**TOWN OF NEWBURGH
PLANNING BOARD
TECHNICAL REVIEW COMMENTS**

PROJECT: 317 NORTH PLANK ROAD SITE PLAN
PROJECT NO.: 18-23
PROJECT LOCATION: SECTION 35, BLOCK 3, LOT 6 & 7
REVIEW DATE: 12 JULY 2019
MEETING DATE: 18 JULY 2019
PROJECT REPRESENTATIVE: HUDSON LAND DESIGN

Re: Site Plan Application
317 North Plank Road
Tax Parcels 35-3-7; 35-3-6
Town of Newburgh, New York
Newburgh Planning Board Job #: 2018-023

TITLE: SP-1

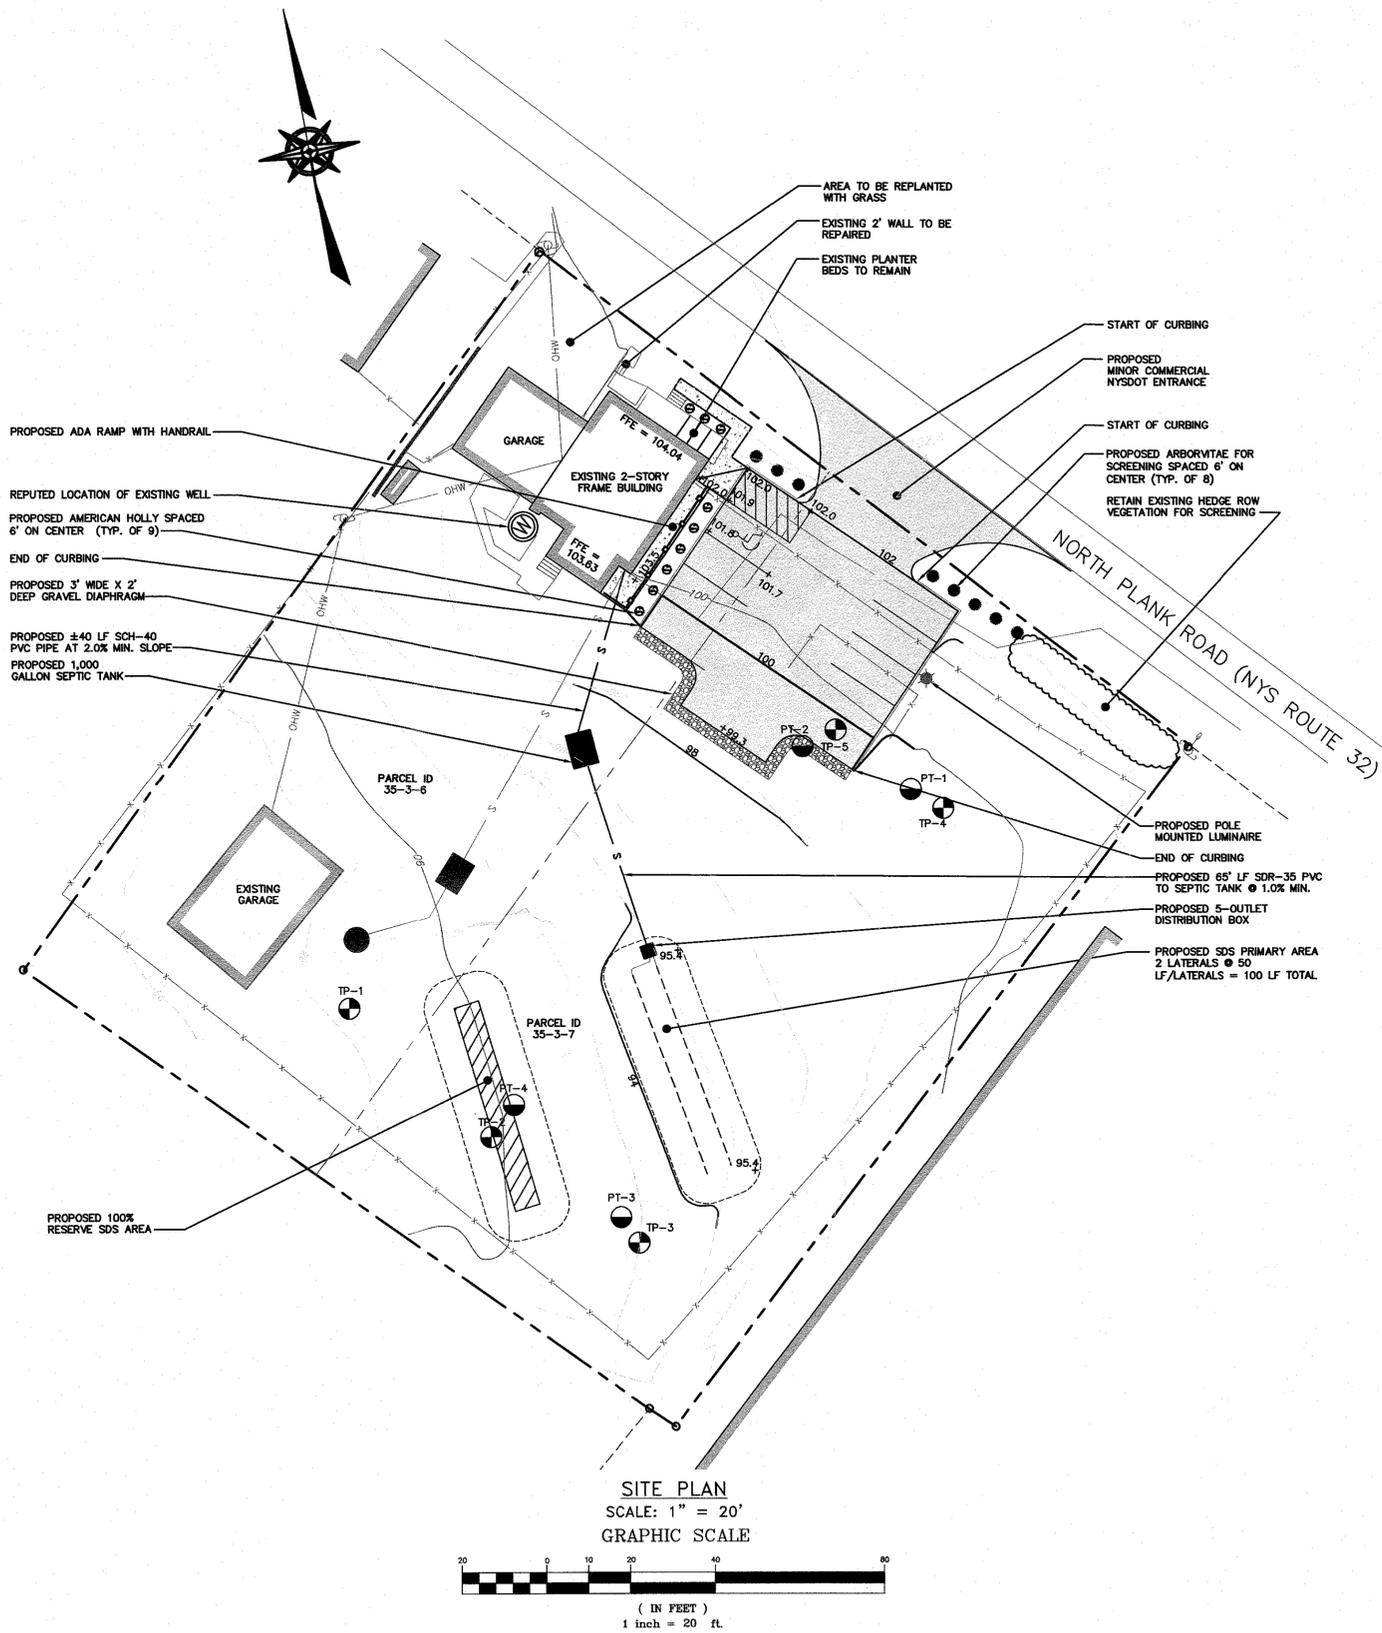
5. Notes pertaining to the requirement to submit an As-Built plan and Certification for the subsurface sanitary sewer disposal system must be added to the plans. Subsurface sewage disposal Note #3 identifies a pump chamber while one is not identified on the plans.

10. Landscaping plan identifies the placement of eight(8) Arborvitae along the frontage and nine American Holly. Planning Board should evaluate the use of the Arborvitae along the roadway frontage.
11. The Applicants are proposing a pea gravel diaphragm to provide for run-off treatment from the nine (9) space parking lot proposed.

6. The detail on Sheet 3 was revised to include a 1,000-gallon septic tank, while the 1,500-gallon septic tank detail was removed.
7. This existing garage will not be utilized for parking vehicles as required by the NYSDOT. The asphalt in front of and around garage will be removed and a low growing grass will be applied. No parking will occur in front of garage.

1. The parking lot was shifted 5 feet to the east to allow the planting of six (6) American Holly to soften the view of the ADA compliant ramp. Three (3) additional American Hollies are proposed in between the front walk and the existing planting bed adjacent to the front stairs.

5. Overhead wires exist between the subject parcel and North Plank Road. It is proposed to keep the existing mature trees and vegetation where not in conflict with the proposed parking area. Mature trees are setback from ingress and egress points in excess of 15 feet. Sight lines are currently in conformance and will not be impacted in the future. To supplement the existing vegetation that will be removed, eight (8) Arborvitae are proposed along the frontage of the proposed parking area.

PARKING AND STRIPING DETAIL
NOT TO SCALE

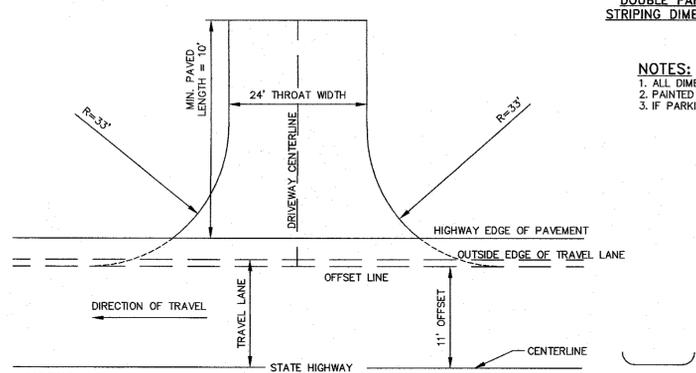
8. Credit for parking spaces in front of existing garage appears to be taken, access to the garage should be identified on the plans.
9. Parking Note #3 should be evaluated as it appears that nine (9) parking spaces, including one

8. A NYSDOT Minor Commercial Detail has been added to Sheet 4 of the plan set.
9. Parking Striping Detail – To be provided from Town Engineer per conversation at Planning Board meeting; however, the parking detail has been revised to reflect the Town's double stripe between parking spaces.

NYSDOT TYPE 1 MINOR COMMERCIAL ENTRANCE DETAIL
NOT TO SCALE

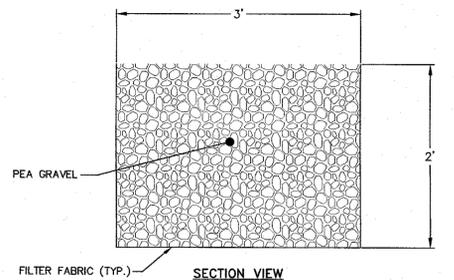
6. Show separation between well and septic system if well is allowed to remain.
7. NYSDOT access drive details do not depict curbing. Curbing is proposed along two sides of the parking lot.

10. A Zoning Bulk Compliance table is located on Sheet 2 of the plan set.
11. Per conversations with the NYSDOT, curbing at entrance shall not be proposed. The applicant is requesting a waiver from the Planning Board for no curbing around the end of the parking area to allow free sheet flow into the pea gravel diaphragm. The limits of the proposed concrete curbing are labeled on Sheet 2 of the plan set.
